We have completed our review of adequacy of Station Electric Distribution System Voltages for Oconee Nuclear Station, Units Nos. 1, 2 and 3. Our enclosed Safety Evaluation is based on EG&G Technical Evaluation Report, EGG-EA-6131.

SAFETY EVALUATION  
OCONEE NUCLEAR UNITS 1, 2, AND 3  
DOCKET NOS. 50-269/270/287  
ADEQUACY OF STATION ELECTRIC DISTRIBUTION SYSTEM VOLTAGES

ADEQUACY OF STATION ELECTRIC DISTRIBUTION SYSTEM  
VOLTAGES, OCONEE NUCLEAR STATION, UNIT NOS. 1, 2  
AND 3

Figure 1. Oconee Electrical Single Line Diagram - Unit 1

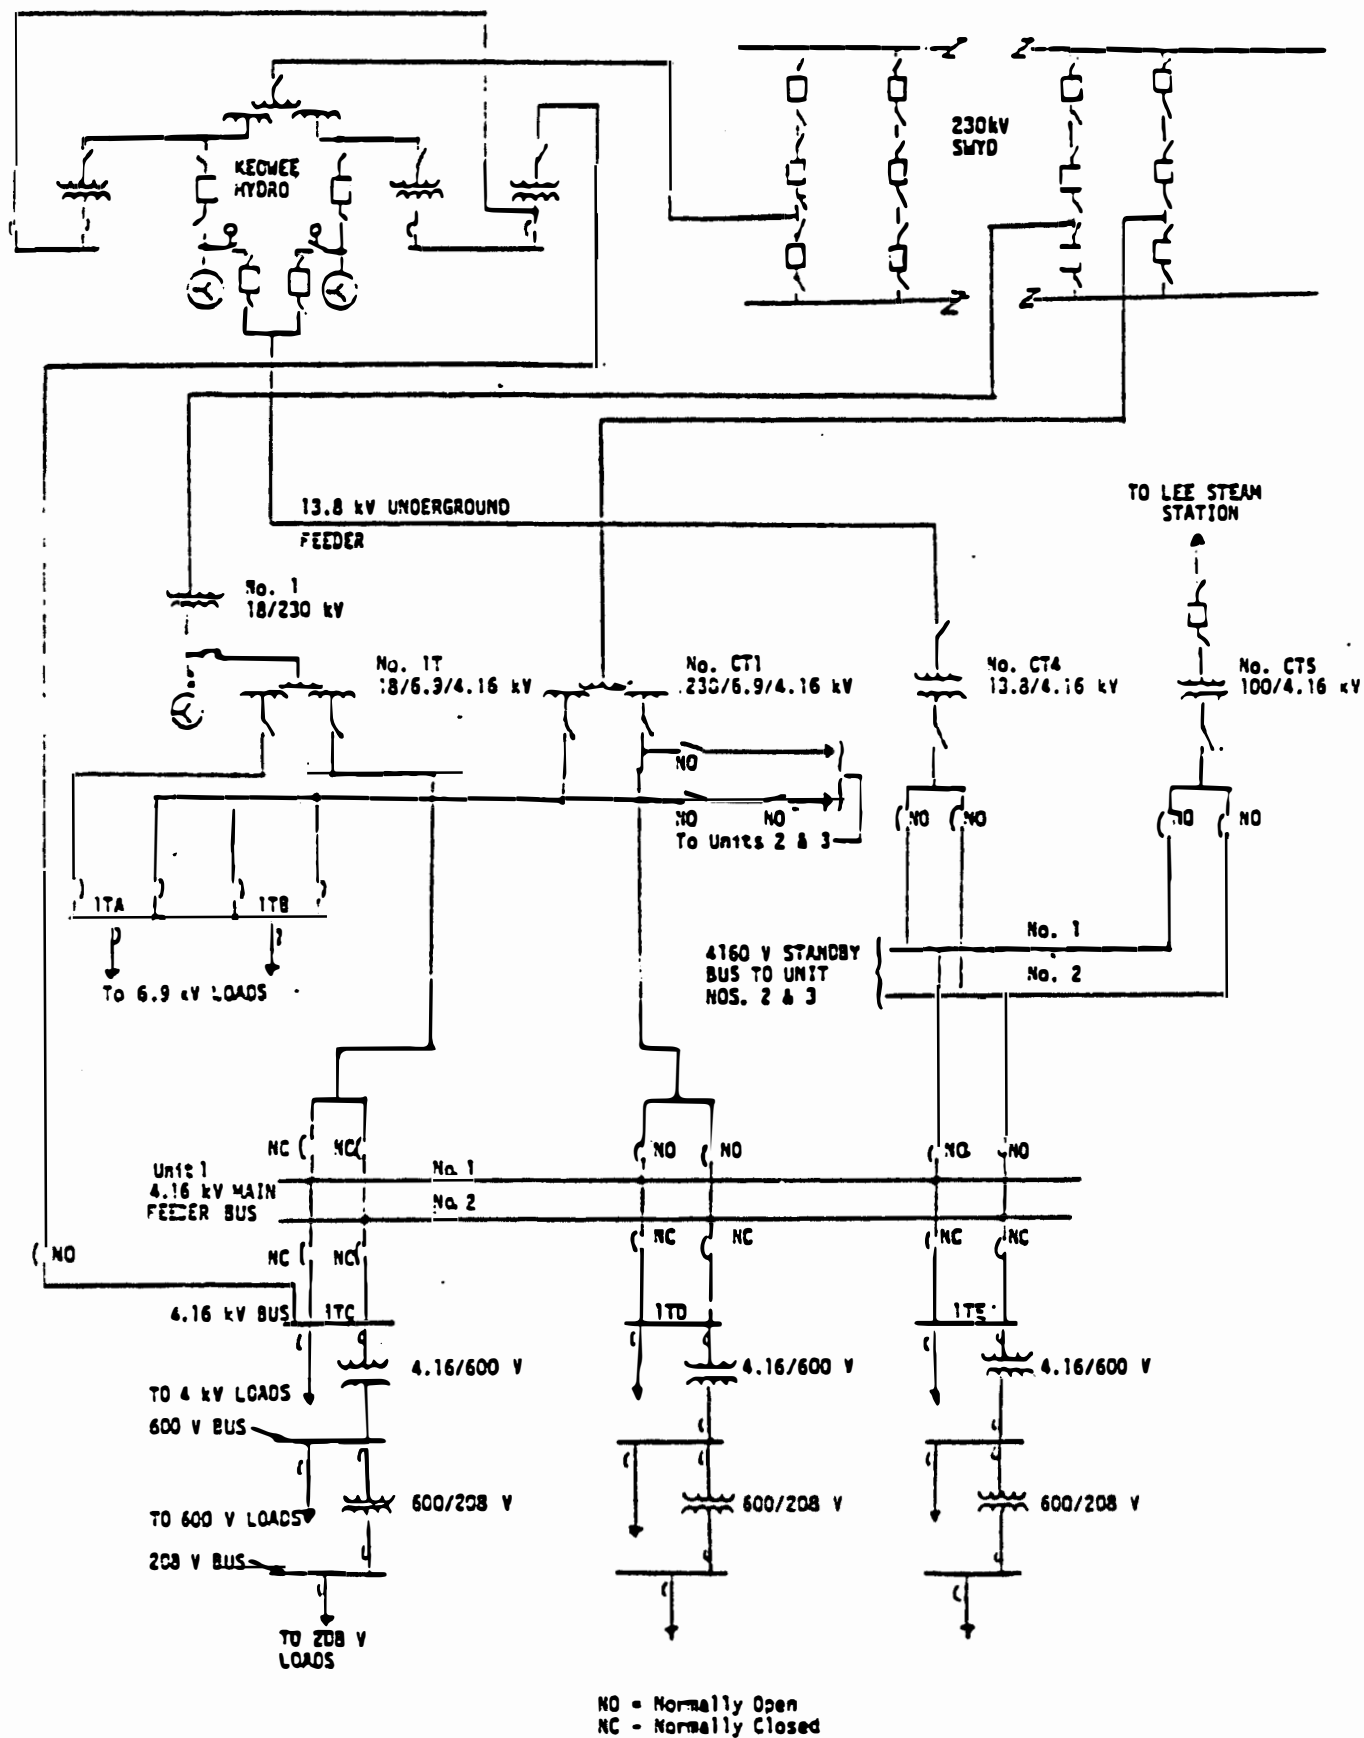
Figure 1 of this report is a simplified sketch of the Oconee electrical single-line diagram. The following description pertains to Unit 1. Unit Nos. 2 and 3 are similar.

During normal plant full-power operation, auxiliary power is supplied by the unit auxiliary transformer No. 1T and during startup and shutdown, by the startup transformer No. CT1 via the 230kV switchyard. Provisions are made for automatic fast transfer of the auxiliary loads from the unit auxiliary transformer to the startup transformer on a unit trip. A second

independent circuit is available from the 230kV switchyard (525kV switchyard for Unit No. 3) to the onsite distribution system via the main transformer and the unit auxiliary transformer for that unit when the main generator bus disconnect links have been removed. Complete loss of all offsite power will result in the automatic transfer to either of the two onsite Keowee hydroelectric generators which are capable of supplying all the emergency and shutdown loads via CT4. Emergency and shutdown loads can also be supplied from a gas turbine generator at the Lee Steam Station via CT5. This generator is isolated from the grid and is considered an onsite source.<sup>5</sup>

There are three essential 4.16kV buses; No. 1TC, 1TD, and 1TE. One division of safety-related equipment is powered from each of these buses. Each bus supplies 4kV loads, the 600V load centers and motor control centers (MCCs), and, in turn the 208V MCC's and the 125/250VDC systems.
